King Street Pump Station Improvements (Volume I) & ASR Lime System Improvements (Volume II) - RFCSP

Solicitation Number: CO-00670

ADDENDUM 3

October 19, 2023

EXISTING TANK LAYOUT PLAN
SCALE: 3/16"=1'-0"

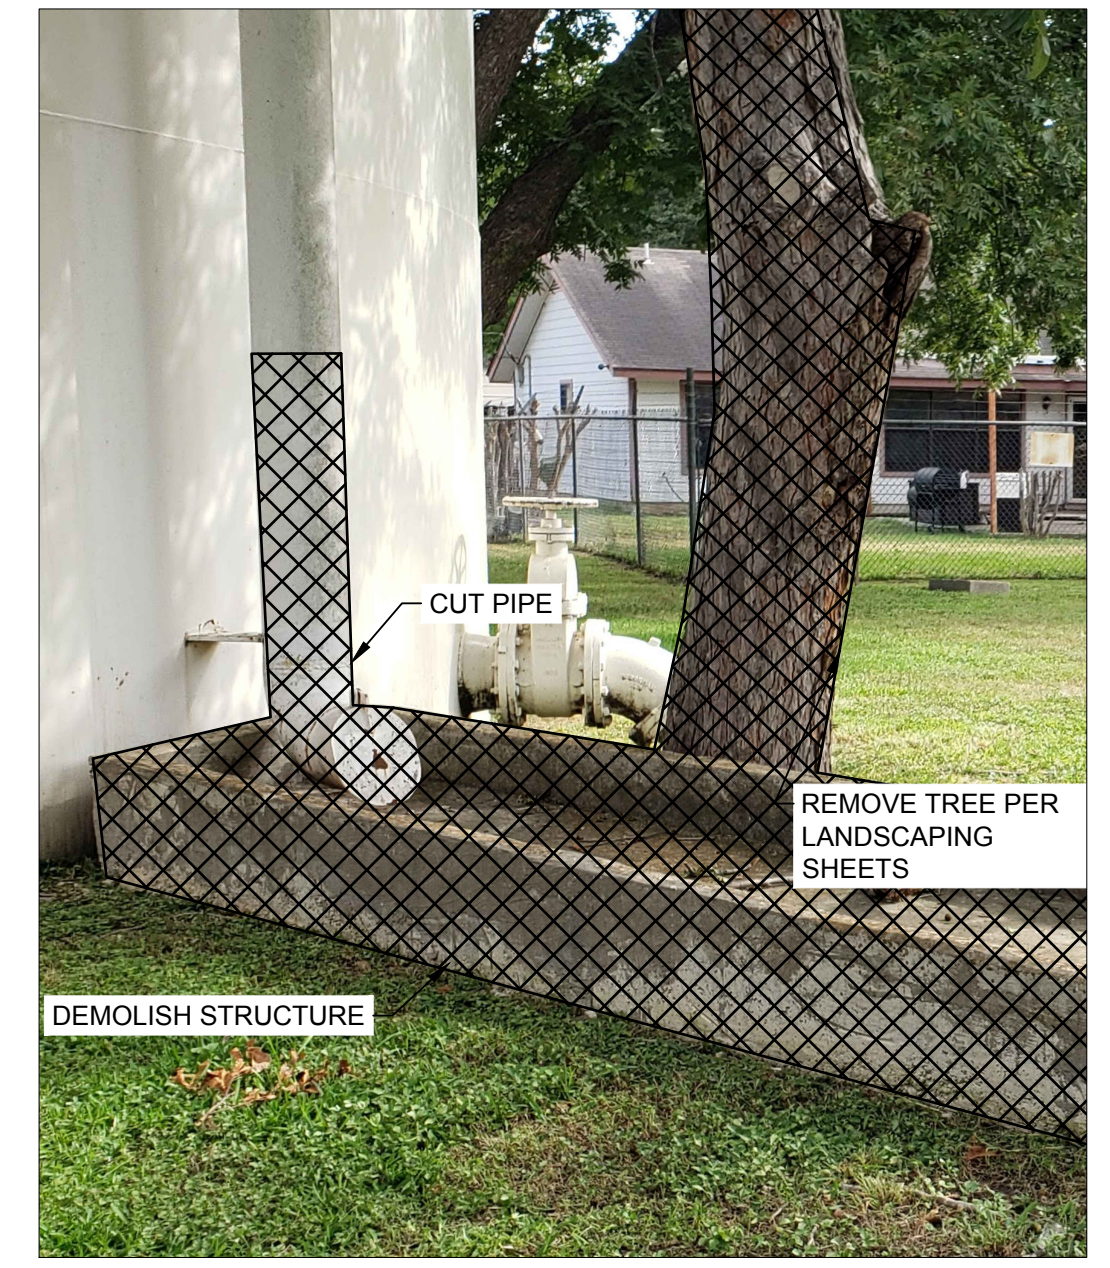
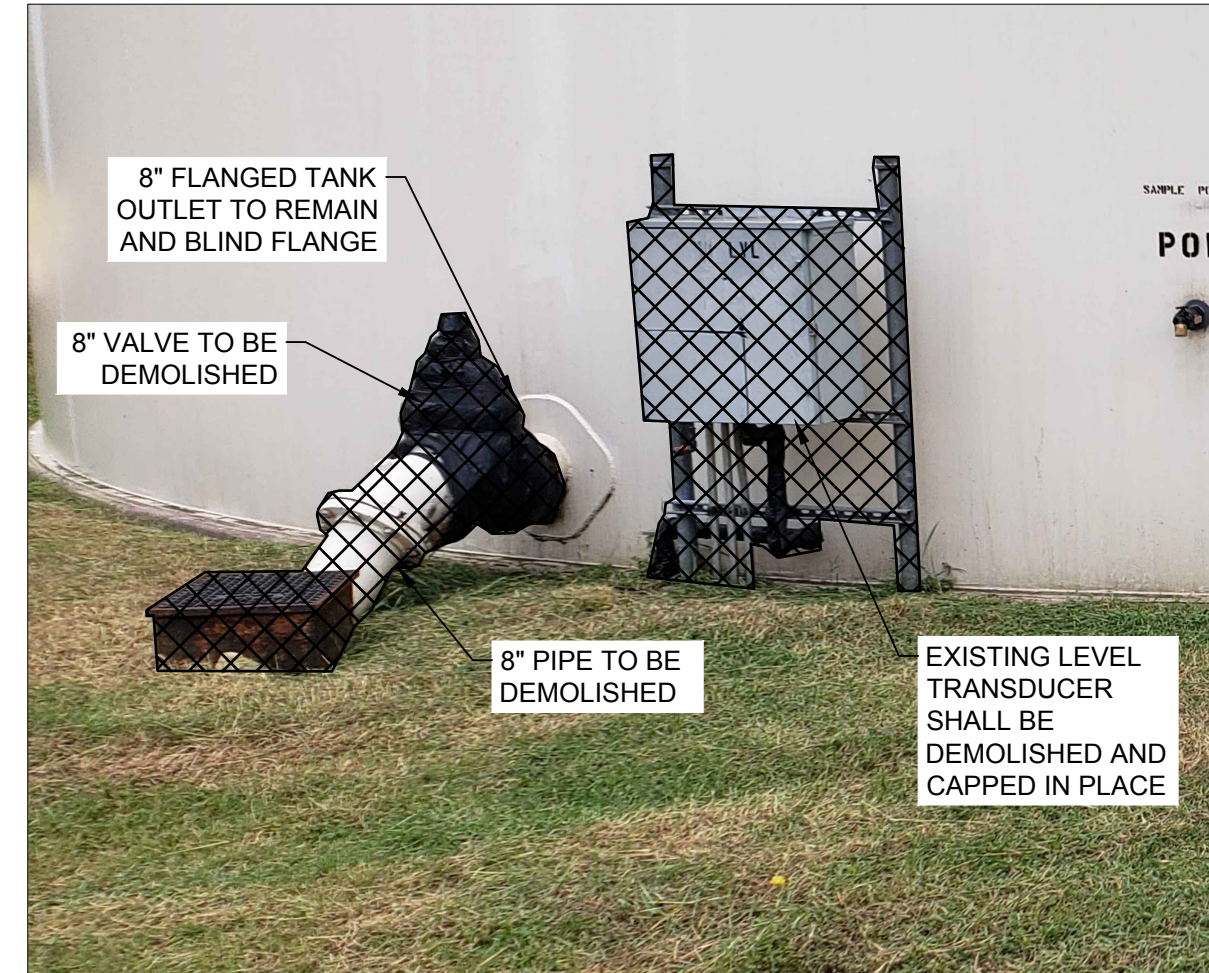
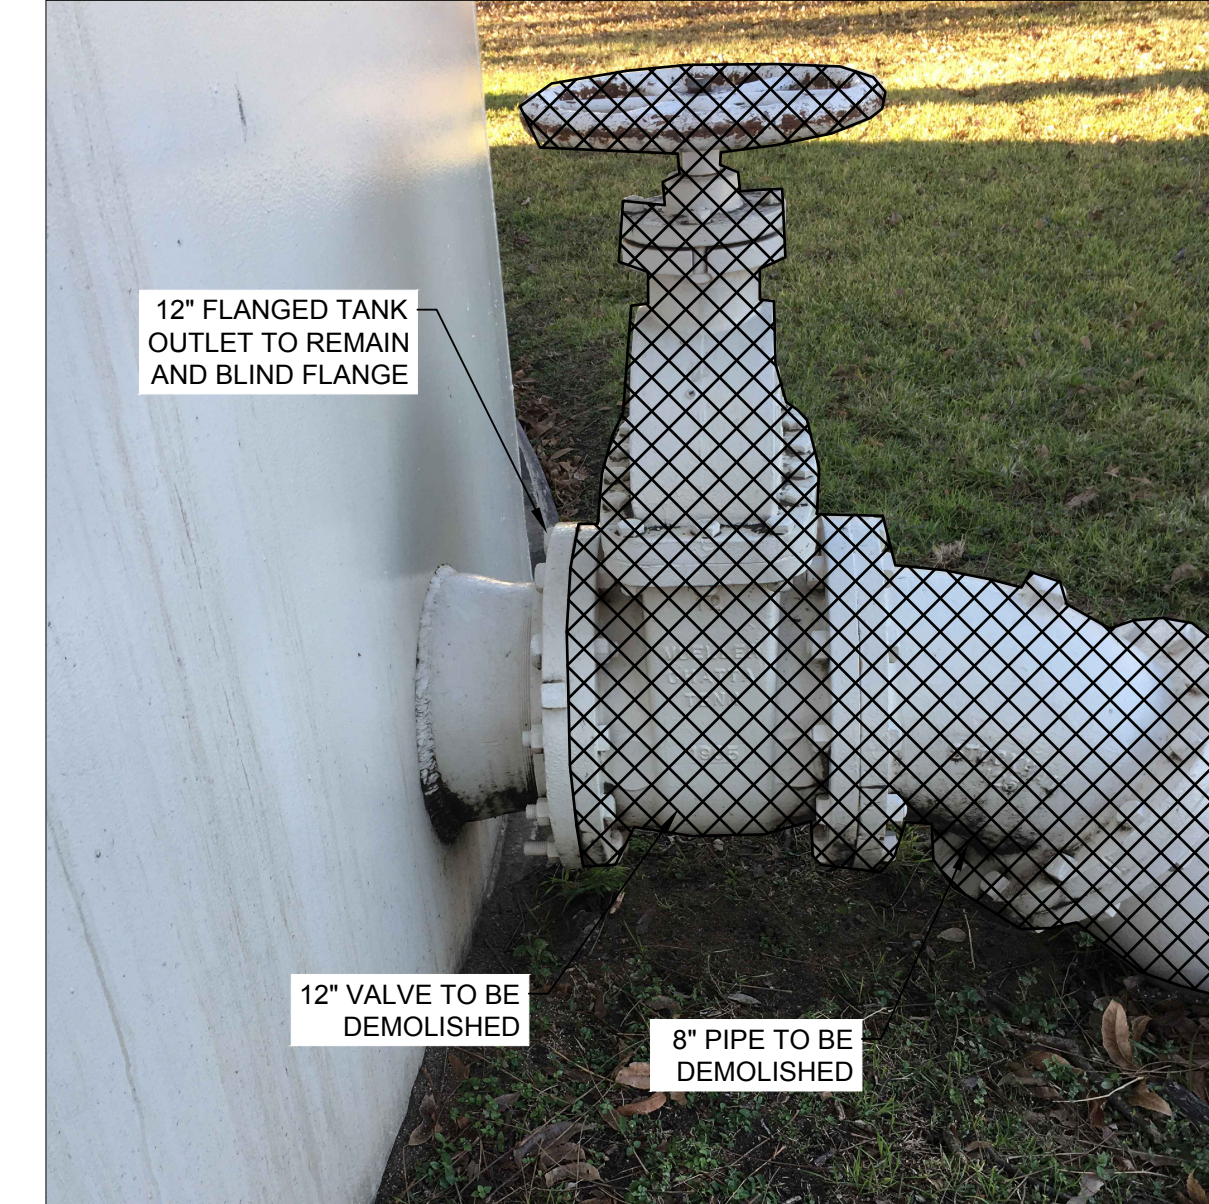
10. **New Pump Station - Drawings D101 & D102 Note 4 states to repair the interior and exterior coating of the existing ground storage tank per 09900. First there is no mention of this in 09900 and secondly, we cannot quantify a sq footage for coating repairs on the tank. Can you either add a bid item with a quantity of sq footage and then clarify what and how the repairs need to be done (prep, coatings etc)?**

Response: Refer to “Changes to Plans” item No. 2 and item No. 3 in this addendum. Interior and exterior coating to be performed as per specification Sections 09871 and 09872 of the contract documents. Drawing D-101 and D-102 refer to the coating damage caused by the demolition and replacement of the inlet nozzle, installation of the inlet reinforcement plate, installation of chemical analyzer sample taps, modifications to the tank overflow pipe, and other work on the tank. The extent of the coating repairs will depend on the means and methods employed by the contractor to accomplish the work and cannot be quantified per sq ft basis. The work is incidental to the tank modifications mentioned above.
